Somerville High School

SHS School Building Committee Meeting

December 12, 2016

Value Management Opportunities

VE-018:

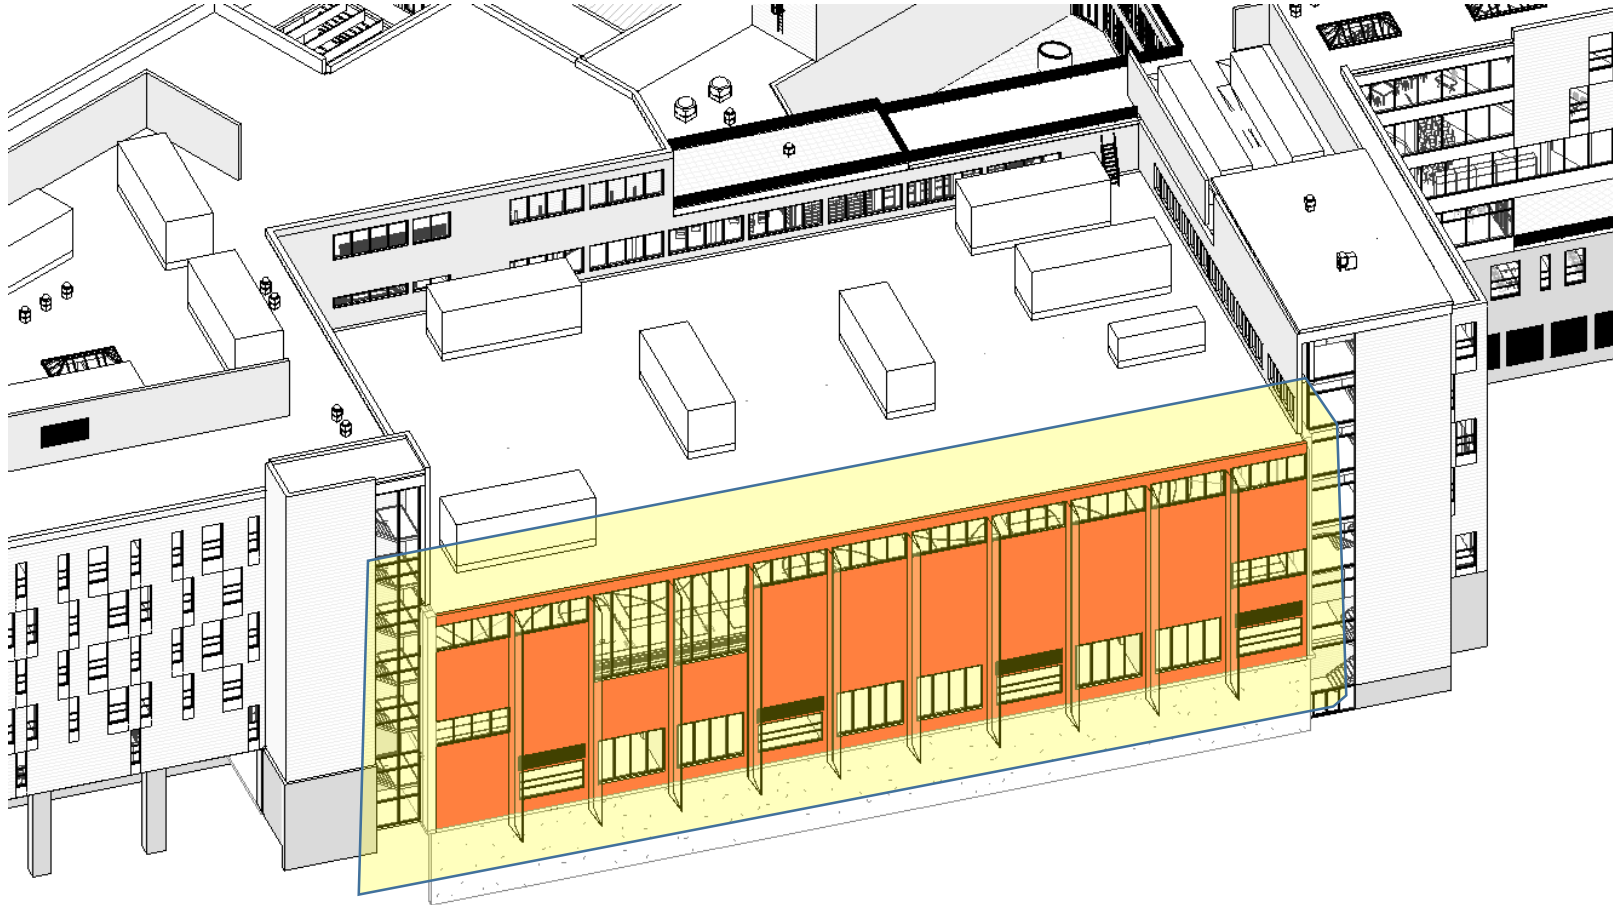
Eliminate green screen/metal panel at rear of Gym,
repointing existing brick only

VE-019:

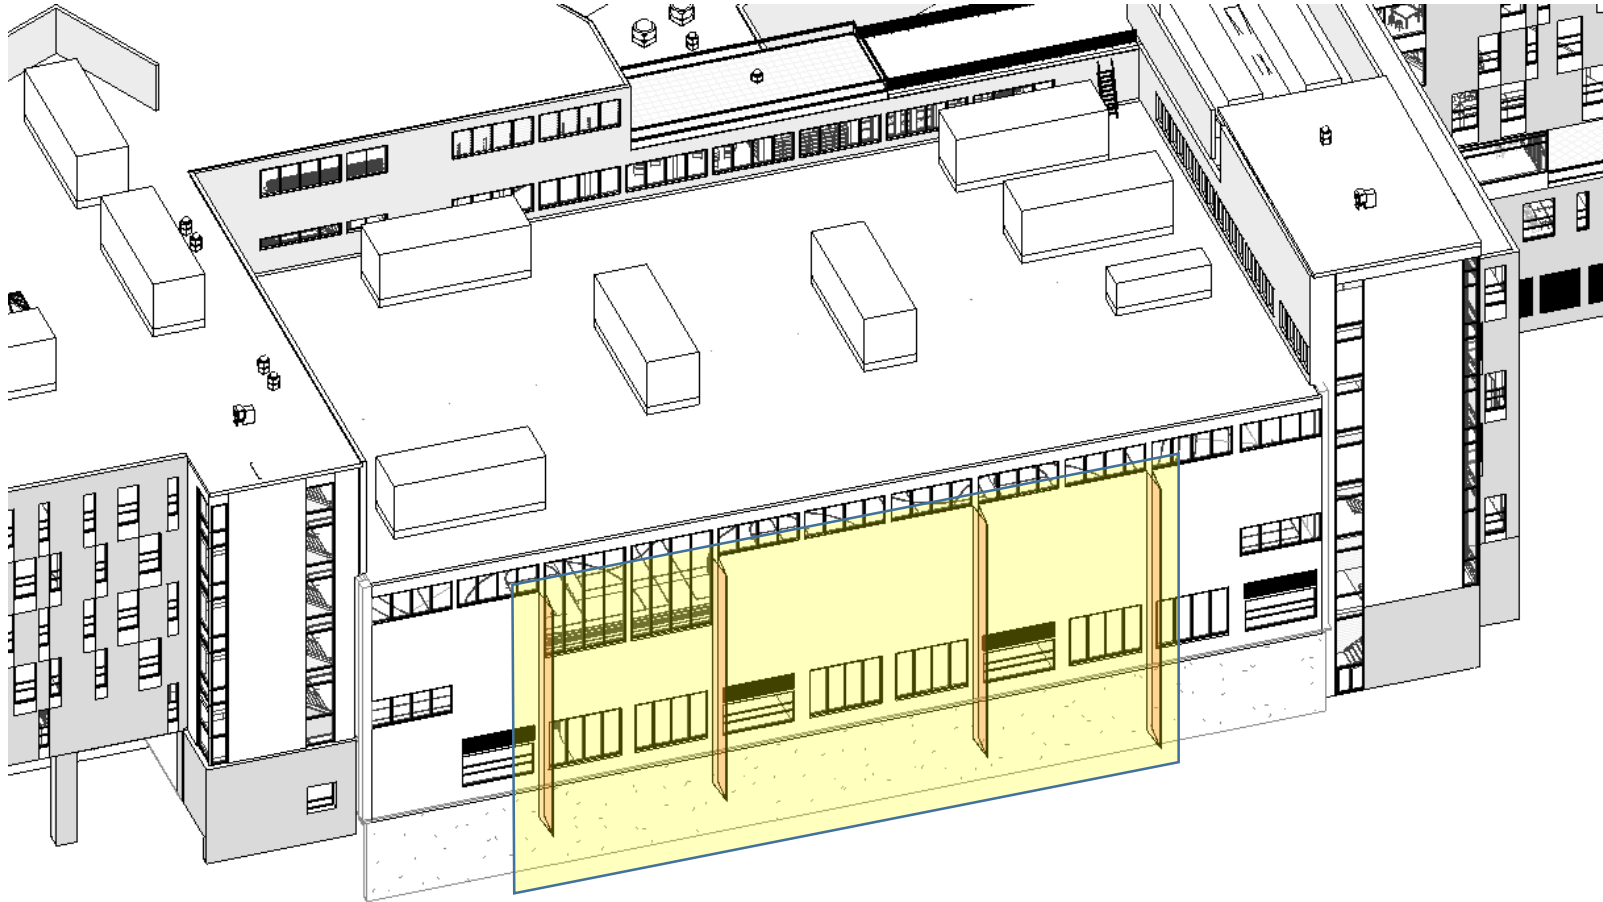
Simplify aluminum fins at existing Gym, reducing linear footage cost by 1/3 with single sided system

VE-026:

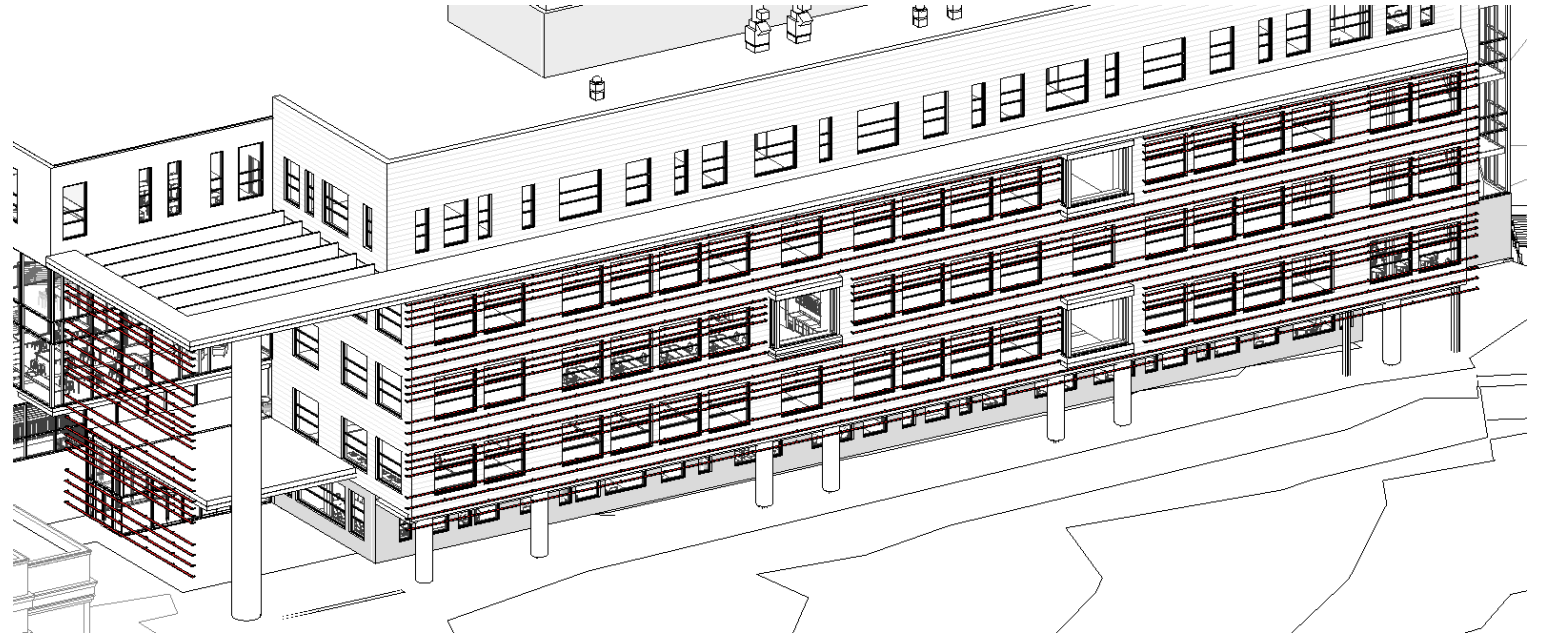
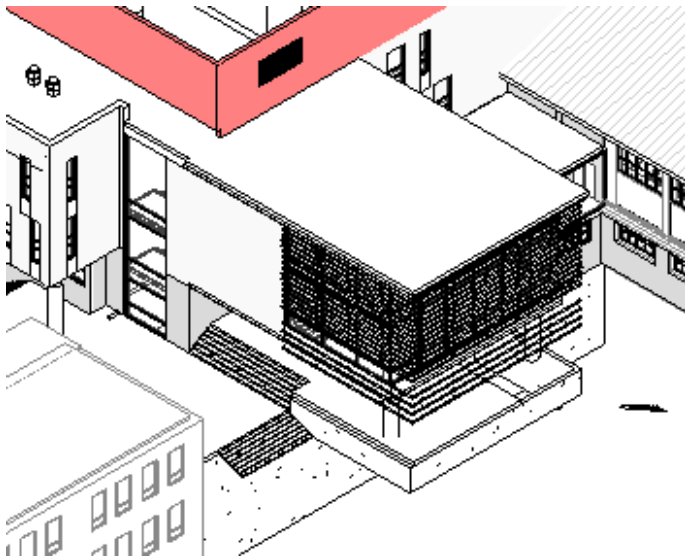
Change terra cotta sunshade to aluminum sunshade

VE-027:

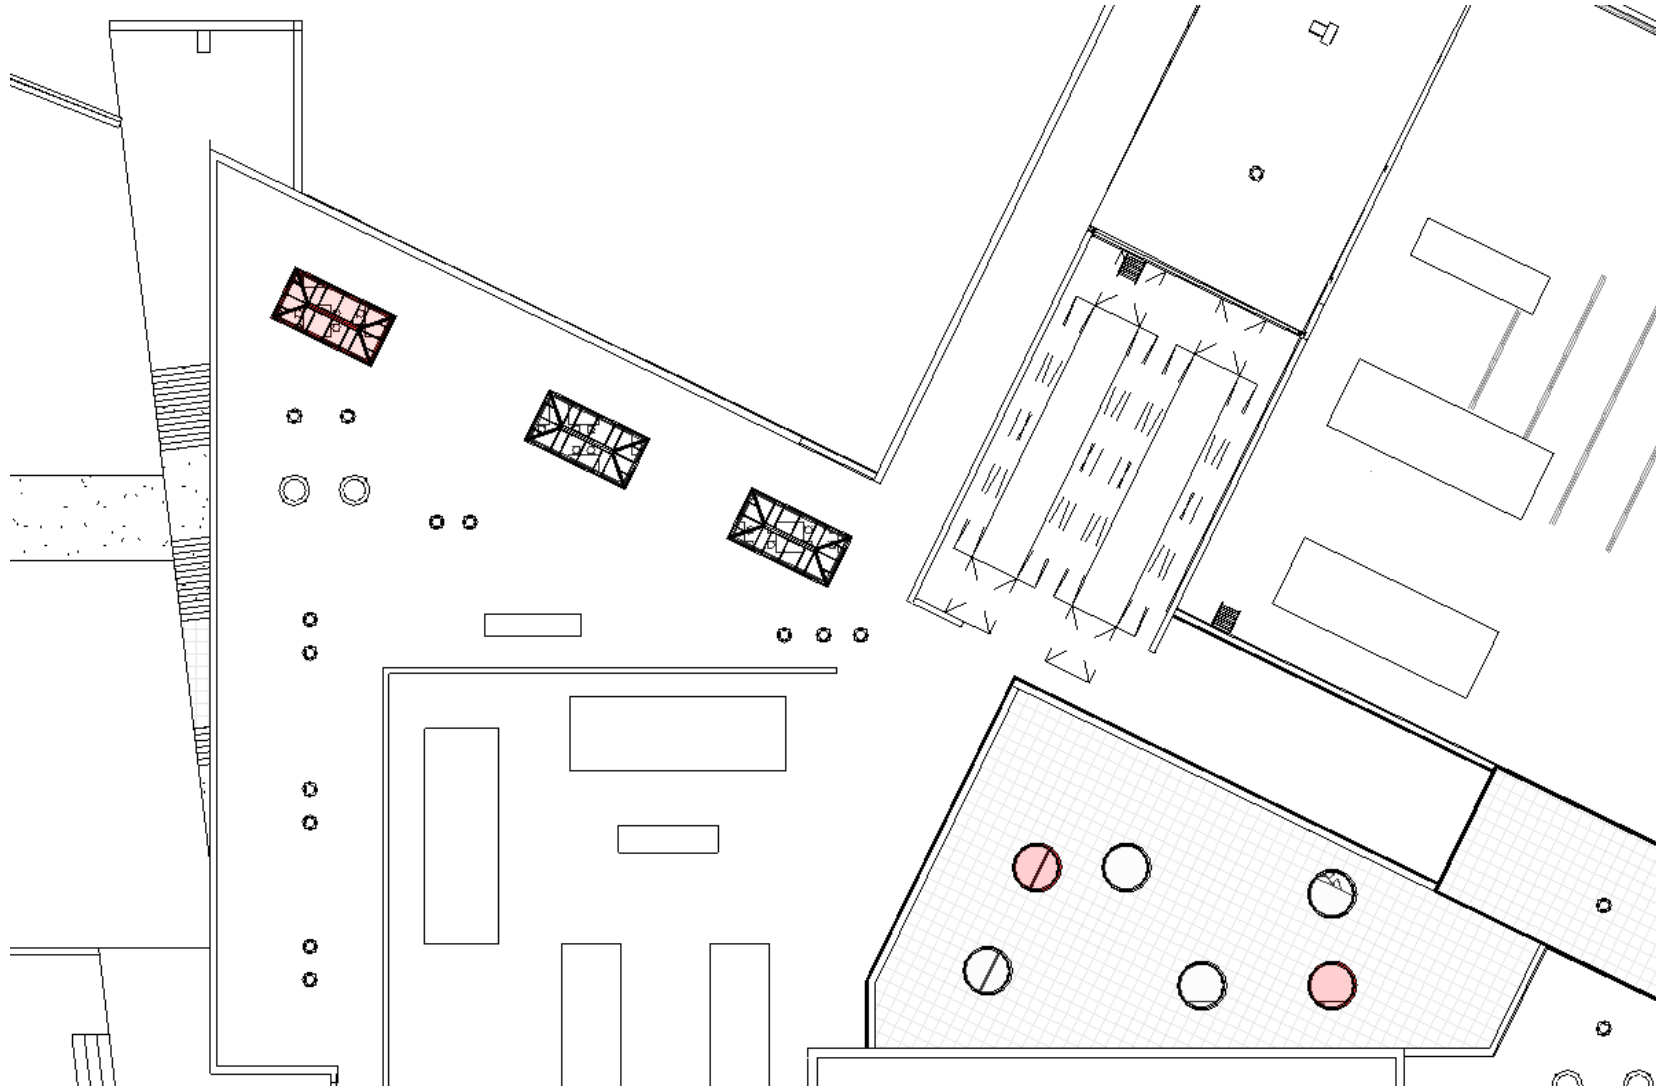
Eliminate (1) rectangular and (2) circular skylights

VE-029:

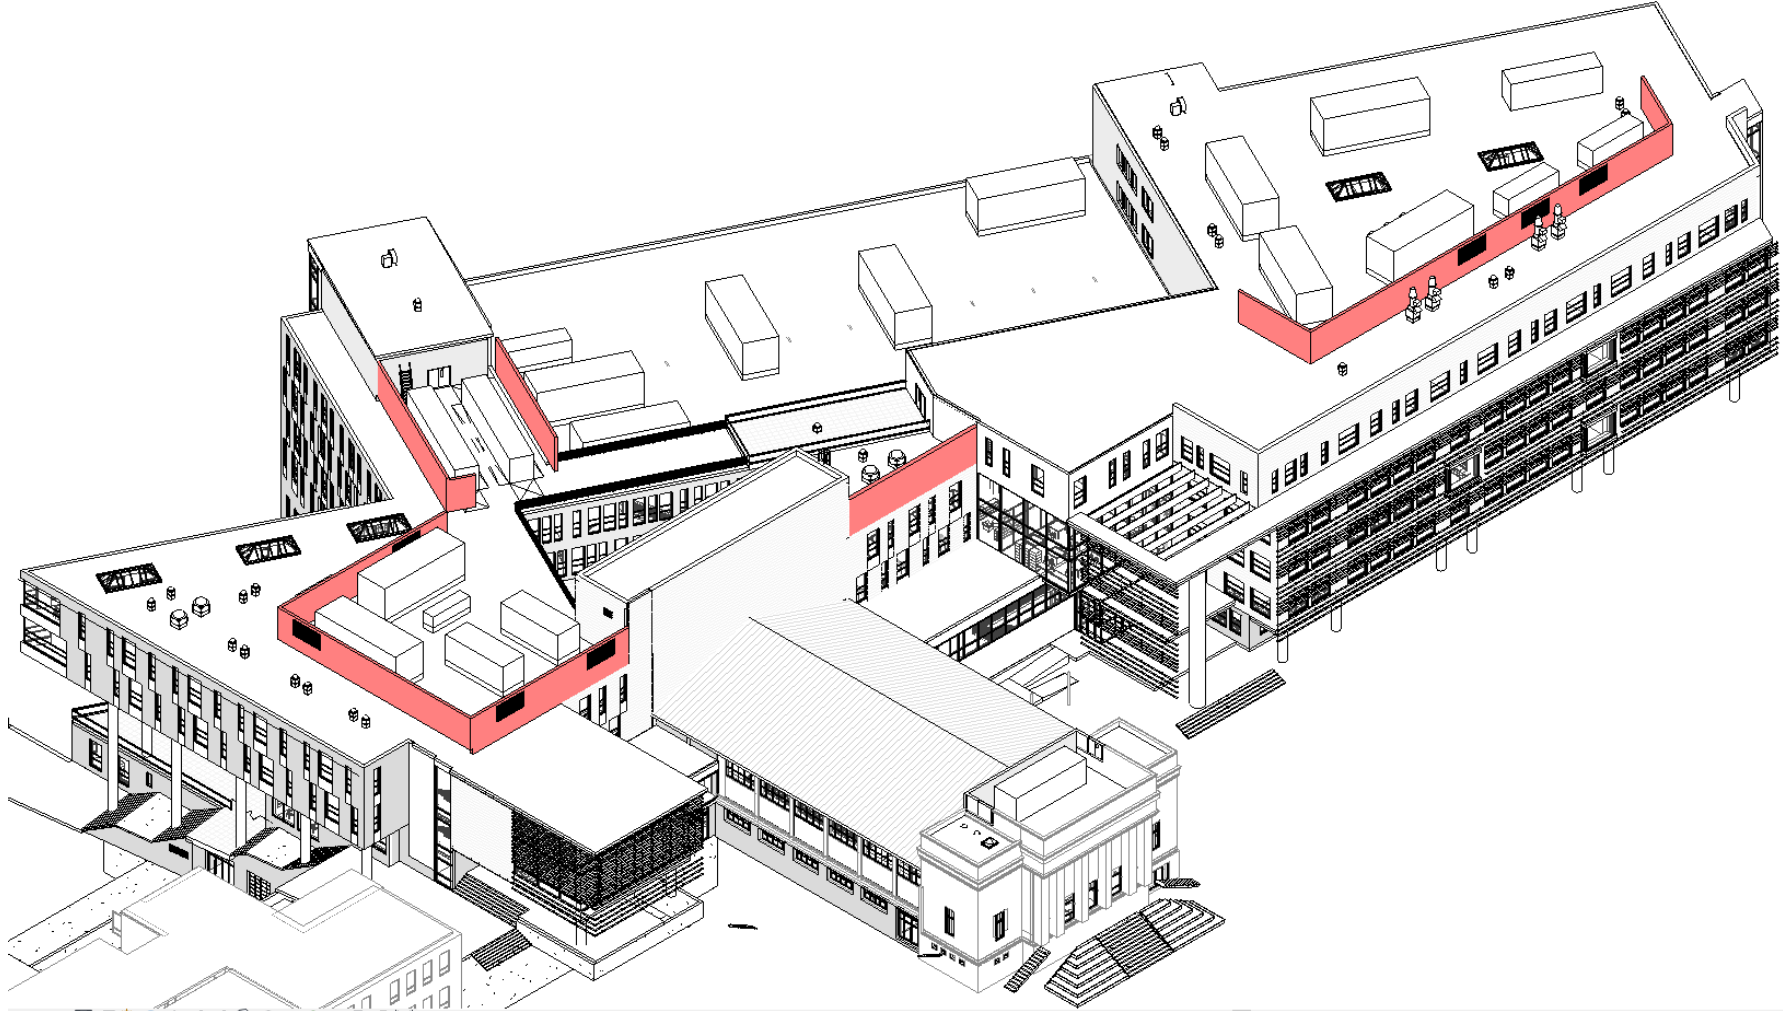
Limit roof screen scope to only critical visual areas,
lowering some and adjusting materials on others

VE-032:

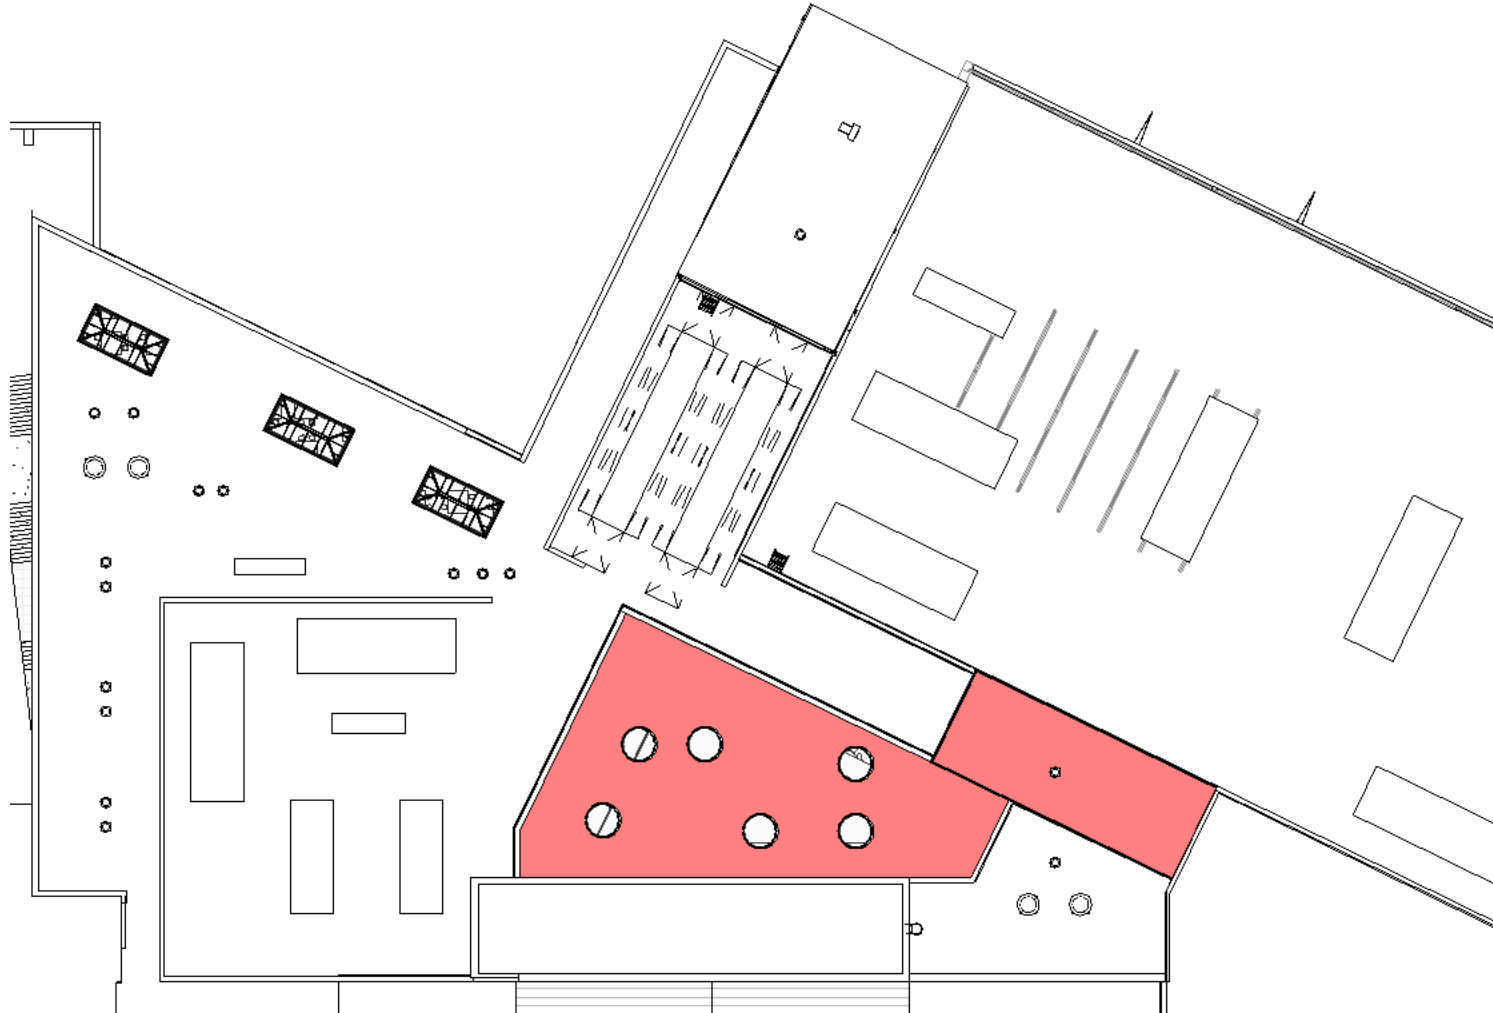
Move Electrical Shop green roof pavers to future install and reduce green roof landscape appurtenances (benches and plant material) at Level 3

VE-033:

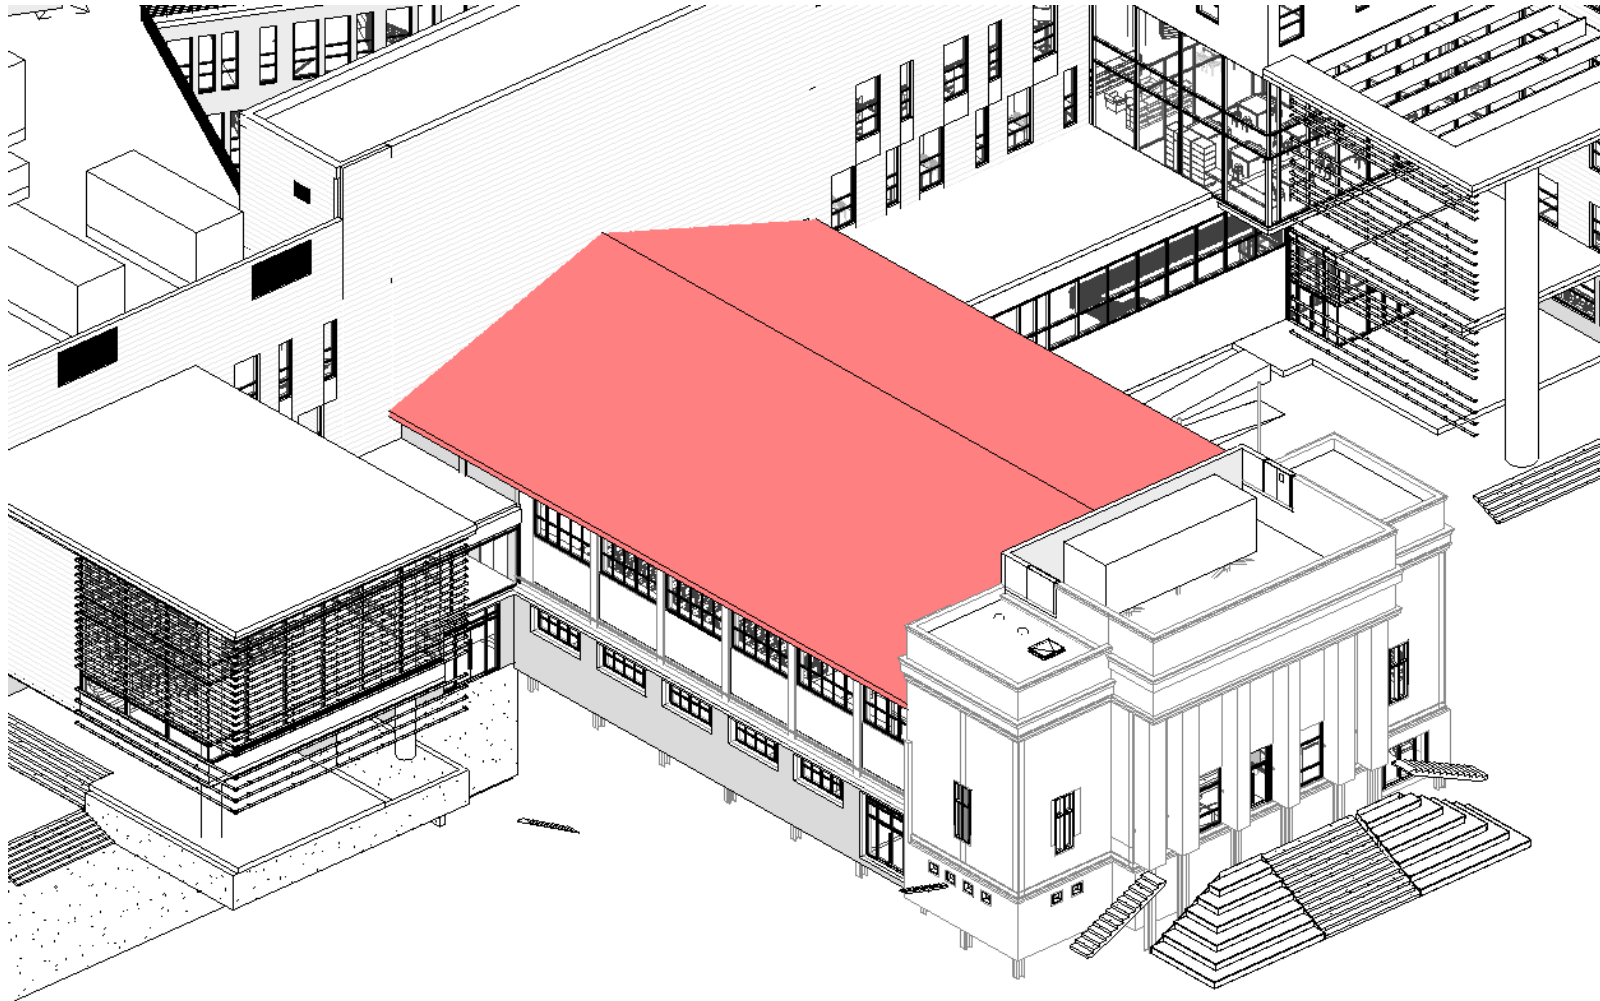
Change Auditorium roof from standing seam copper to standing seam painted metal
